SUMMARY OF PROPOSED
TECHNICAL SPECIFICATION/BASES CHANGES

FERMI 2 TECHNICAL SPECIFICATION/BASES CHANGES

ATTACHMENT 3

TECHNICAL SPECIFICATION
AND BASES CHANGES

FIGURE 3.2.1-1

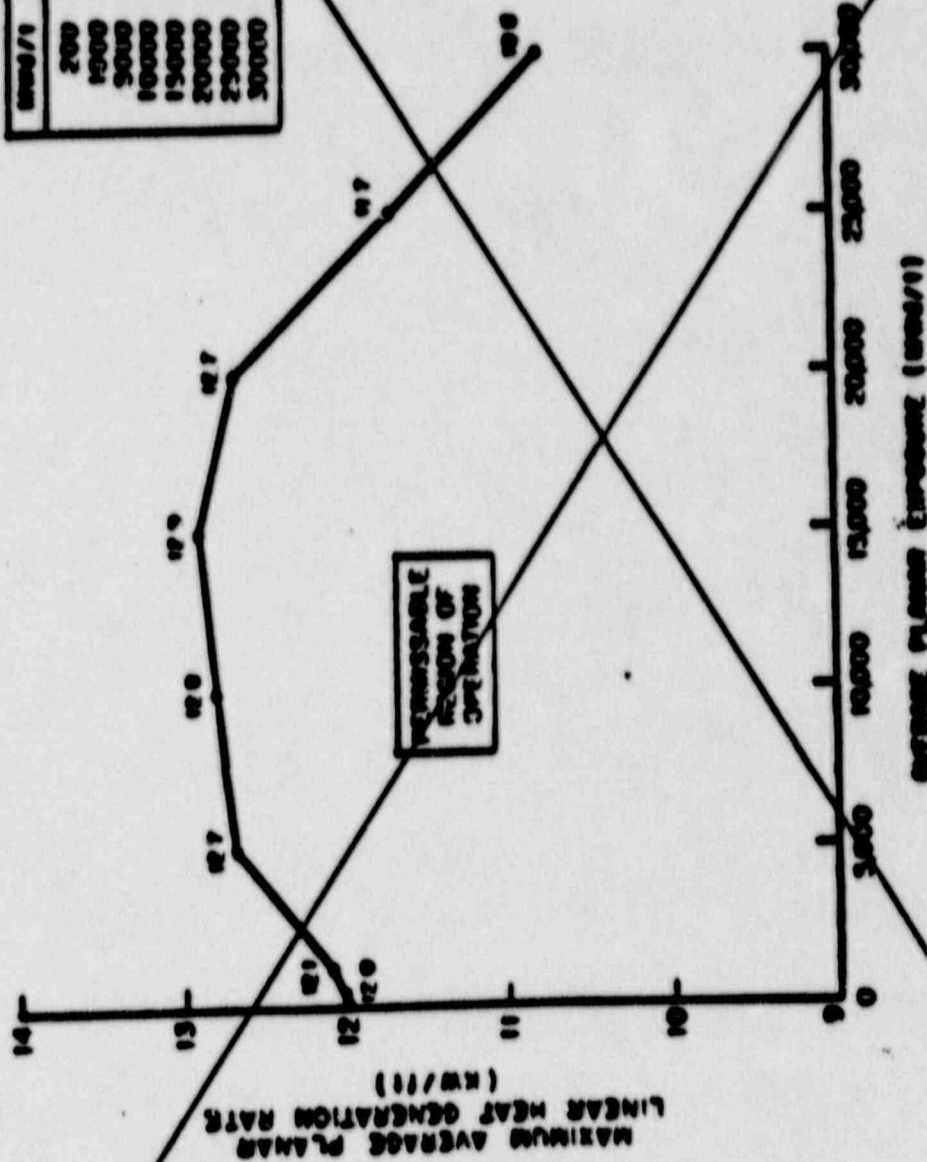
DELETED

MOVED TO CLR

FIGURE 3.2.1-2

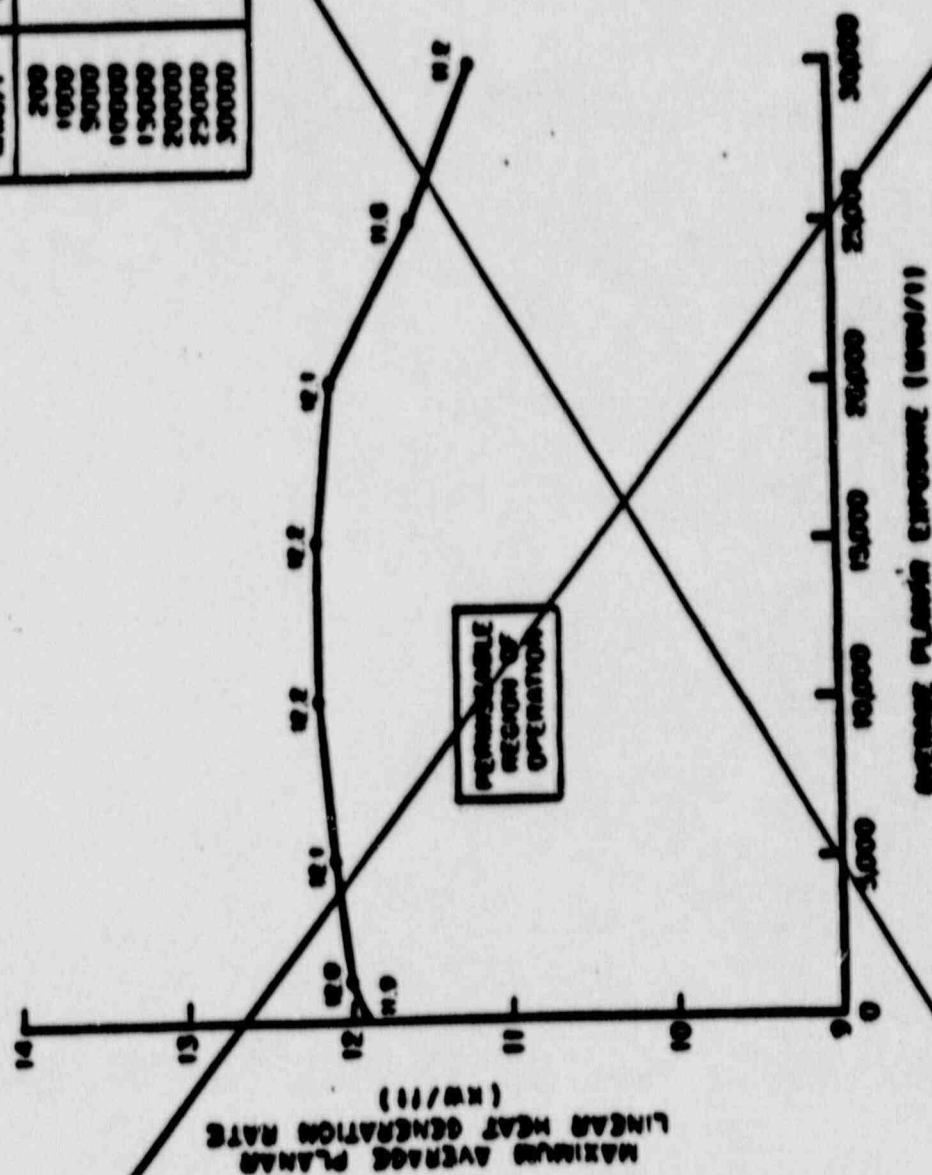
DELETED
MOVED TO
COLR

FIGURE 3.2.1-3

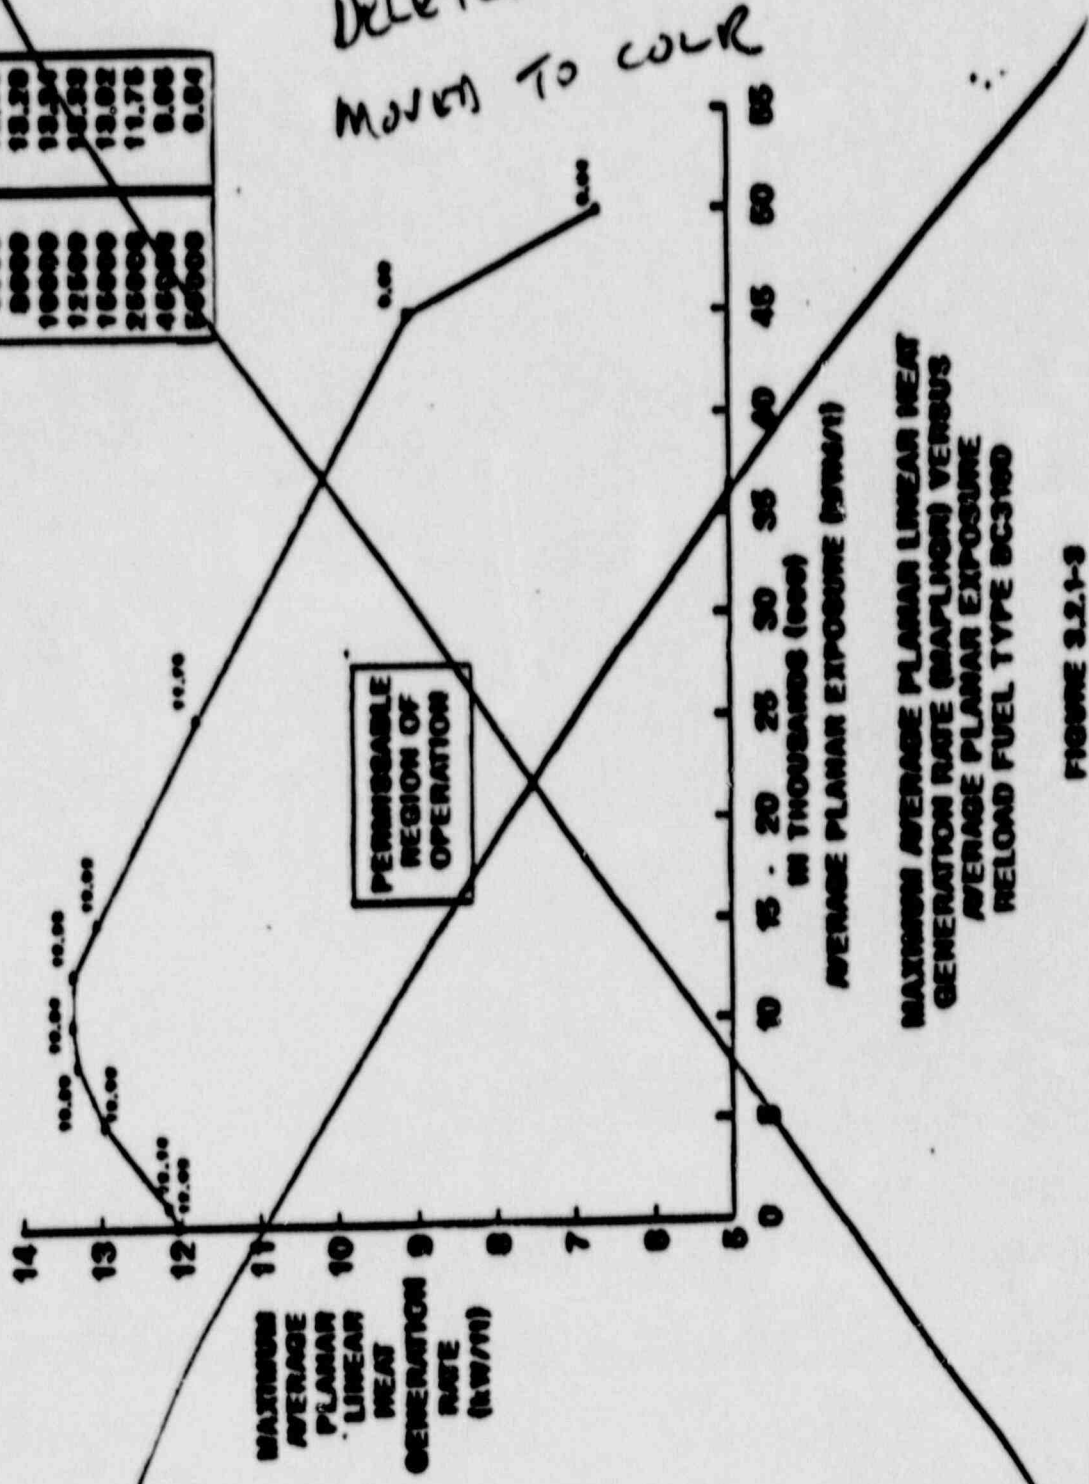
Figure 3.2.1-3 (delete in Index)	MAPLHGR VERSUS AVERAGE PLANAR EXPOSURE (FUEL TYPE BC318D)	Delete cycle-specific bundle MAPLHGR curve and relocate in the COLR. Exposure units changed from MWD/t to GWD/ST upon relocation to the COLR.	3/4 2-4 (xxi)

DELETED
MOVED TO CORR

BOC TO 15,700 MWD/ST
MINIMUM CRITICAL POWER RATIO
(MCPR) VERSUS TAU AT RATED FLOW
FIGURE 3.2.9-1

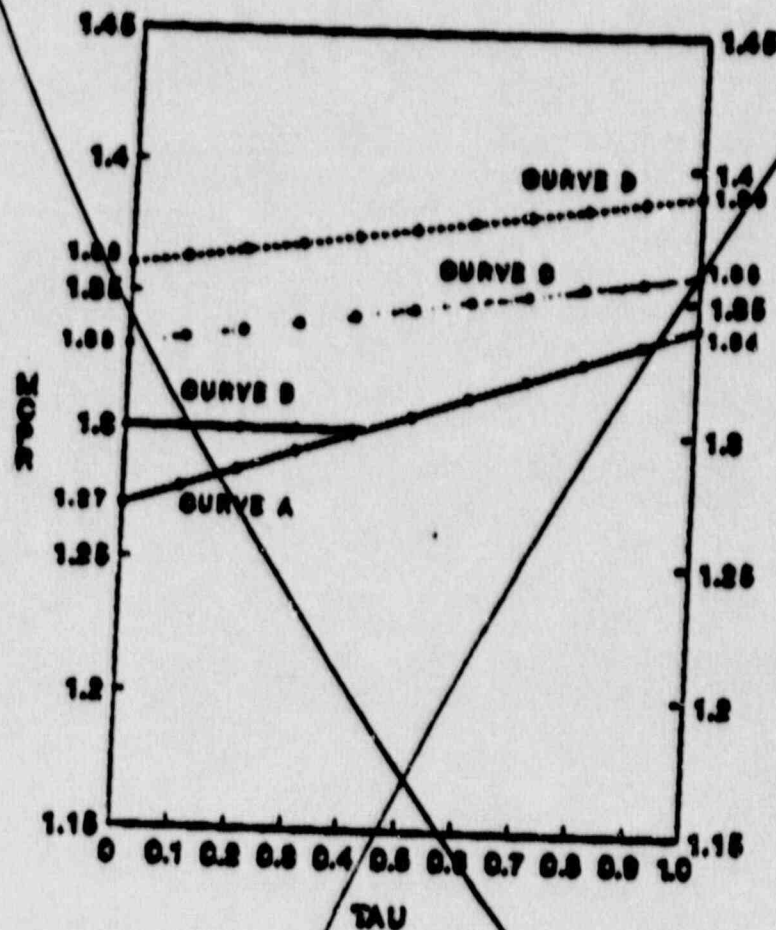
DELETED
MOVED TO COLR

FIGURE 3.2.3-1B

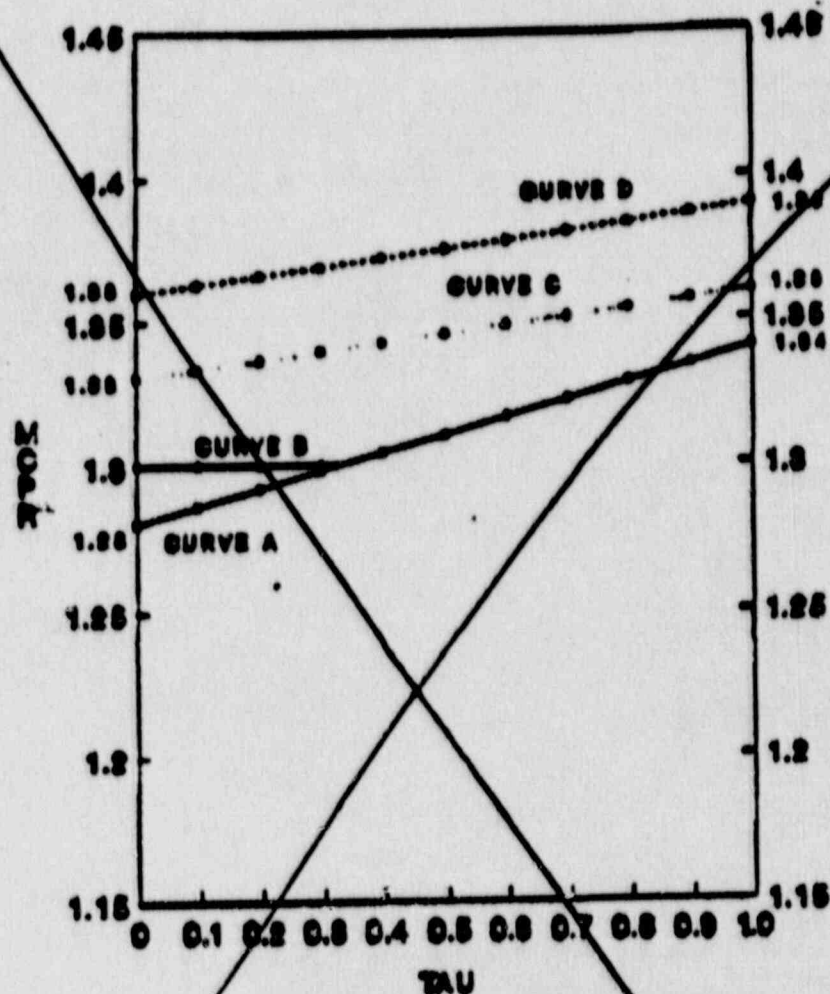
DELETED

MOVED TO CCR

FIGURE 3.2.3-2

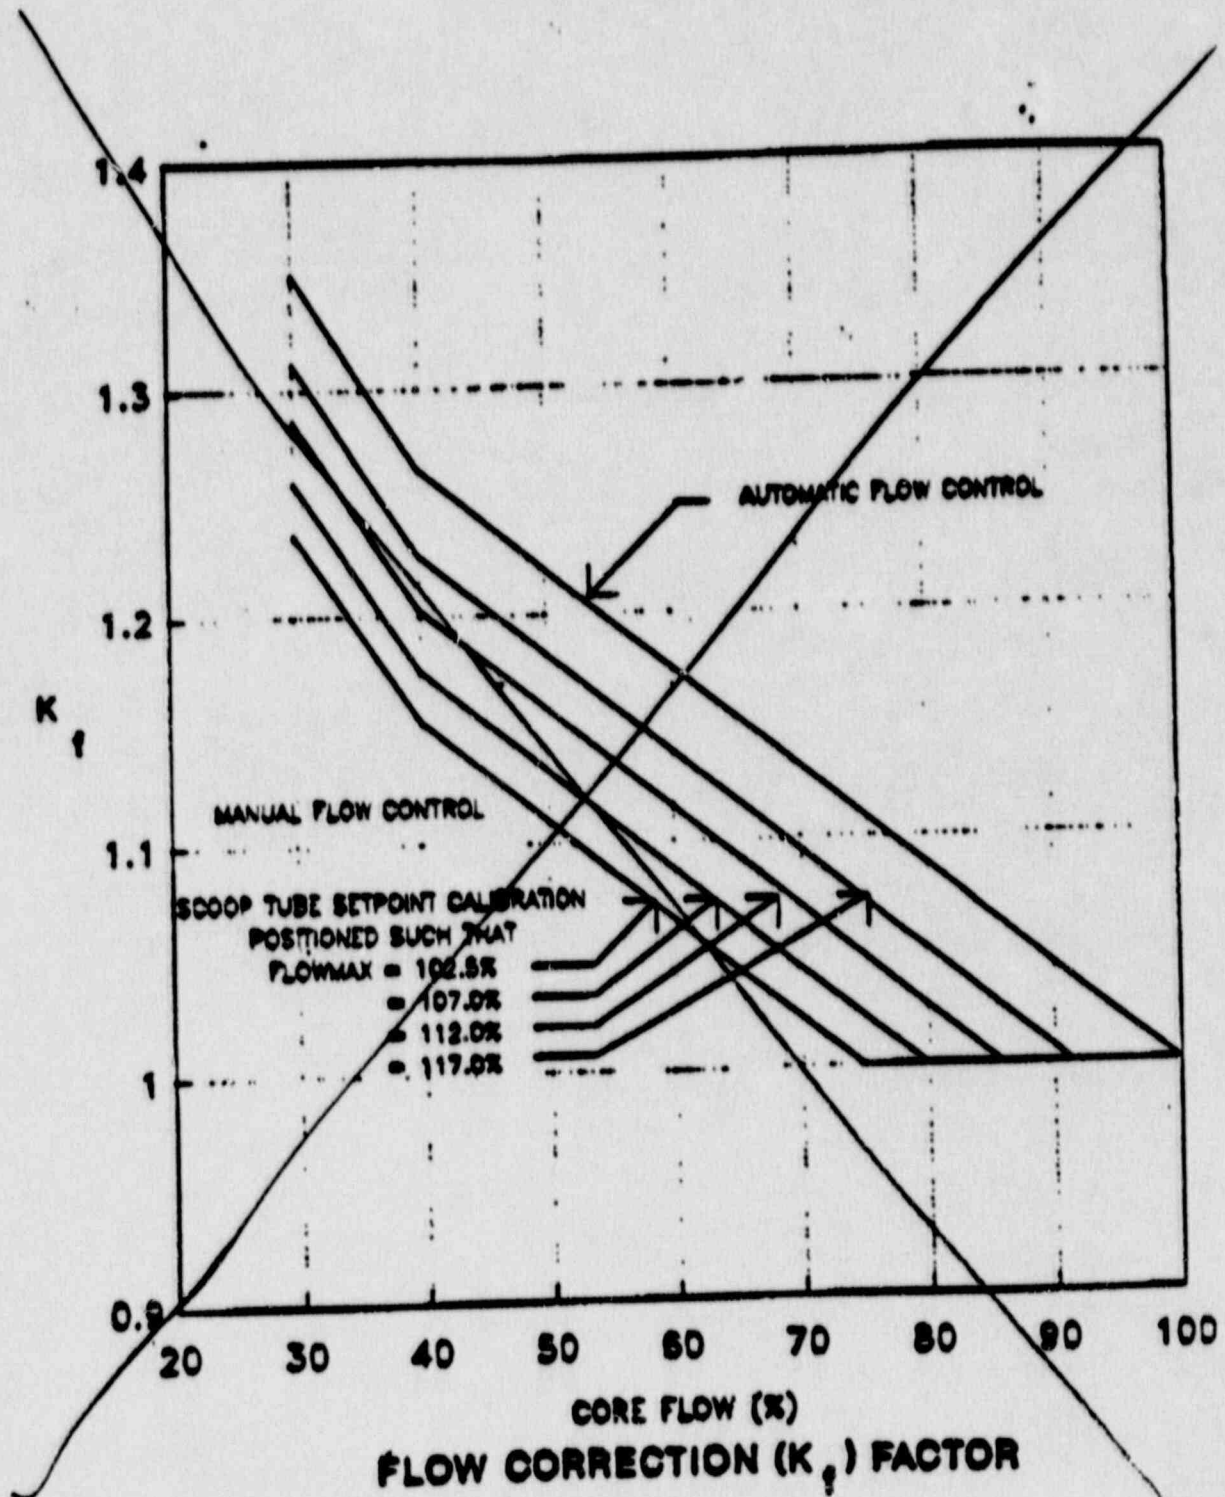
Specification No./ Tables/Figure	Specification Title	Description of Change	Revised Page
Figure 3.2.3-2 (delete in Index)	FLOW CORRECTION (K_f) FACTOR	Delete the cycle-specific K_f curve and relocate in the COLR. Add equations for K_f in the COLR.	3/4 2-9 (xxi)
Spec 3/4.2.4	LINEAR HEAT GENERATION RATE	Delete the cycle-specific LHGR values and relocate the limiting LHGR values in the COLR. Rephrase LCO and Surveillance Requirements for clarity and to correct grammatical errors.	3/4 2-10
Spec 6.9.3 (add in Index)	CORE OPERATING LIMITS REPORT	Add administrative controls for report preparation and submittal in accordance with NRC Generic Letter 88-16 guidance.	6-21 (xx)
Bases 3/4.2.1	AVERAGE PLANAR LINEAR HEAT GENERATION RATE	Change the cycle-specific references to the ALPHGR figures which have been relocated in the COLR. Correct grammatical errors.	B 3/4 2-1

DELETED

MOVED TO COLR
